Rezoning Transportation Analysis

Petition Number: 2020-112

Date	Description
09-11-20	First Review (EL)
04-15-21	Second Review (EL)
8-25-21	Third Review (BB)

FIGURE 1 & 2: Recommended Street cross-sections

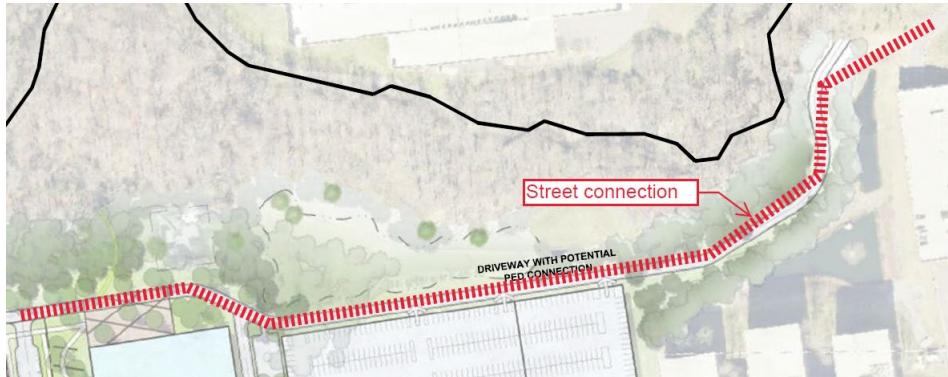
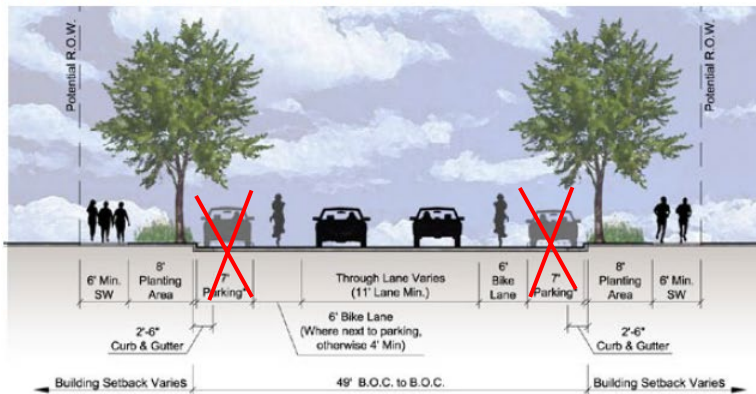
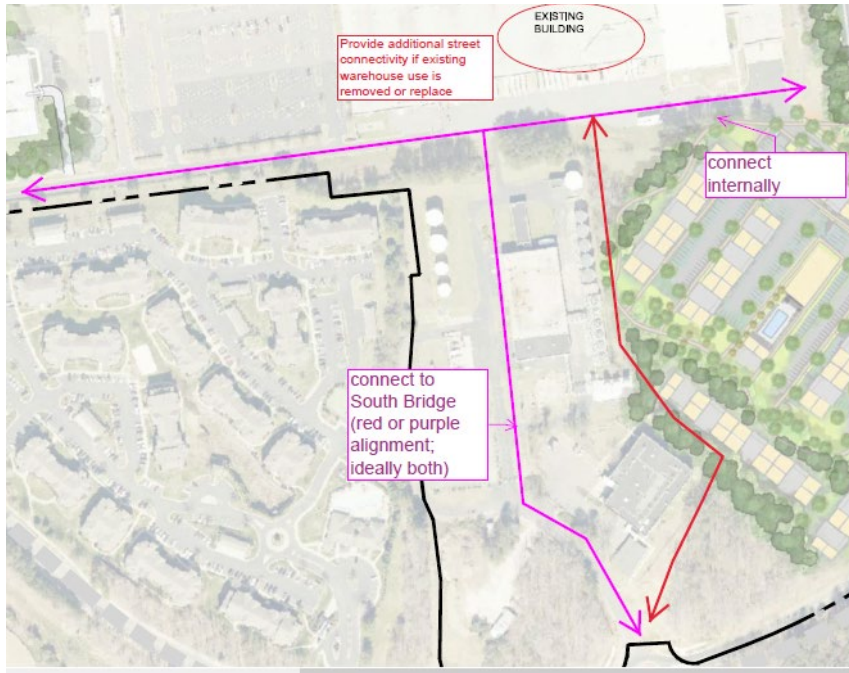
- Updated Comment (Site plan dated 8/16/21):** Revise "Proposed Public Road D" cross-section to include a 4-6' bike lane. The site plan and conditional note(s) need to establish a street connection, as shown below, according to the proposed avenue cross section that is recommended within the University Research Park Area Plan. Refer to pages 38 and 41.

- 49-foot Back of Curb to Back of Curb
Min. 77-foot right-of-way
- 6-foot Sidewalk: Improved pedestrian realm, compliant with ADA (Americans with Disabilities Act)
- Bike Lane: 4-foot Min, 6-foot where on street parking is present - safer bicyclists realm, improved truck turning radius, additional buffer for pedestrians
- Planting area: Buffer for pedestrians; beautification
- On street parking: additional buffer for pedestrians, shared parking, active streetscape

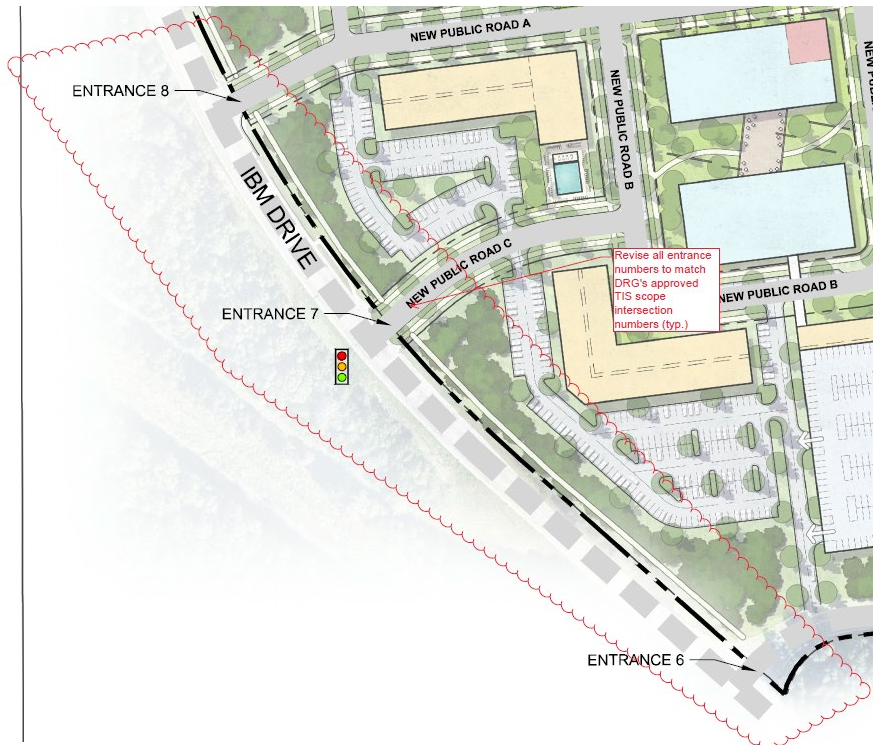
6. Add a note to the site plan specifying dedication and fee simple conveyance of all rights of way to the City before the site's first building certificate of occupancy is issued. CDOT requests right-of-way set at 2' behind back of sidewalk where feasible.
7. Provide additional street connectivity to the north leg of the existing roundabout at the intersection of IBM Drive and University Pointe Boulevard, in the event the existing warehouse use circled below is removed or replaced. These street connections are important to redistribute traffic to multiple access points along IBM Drive.
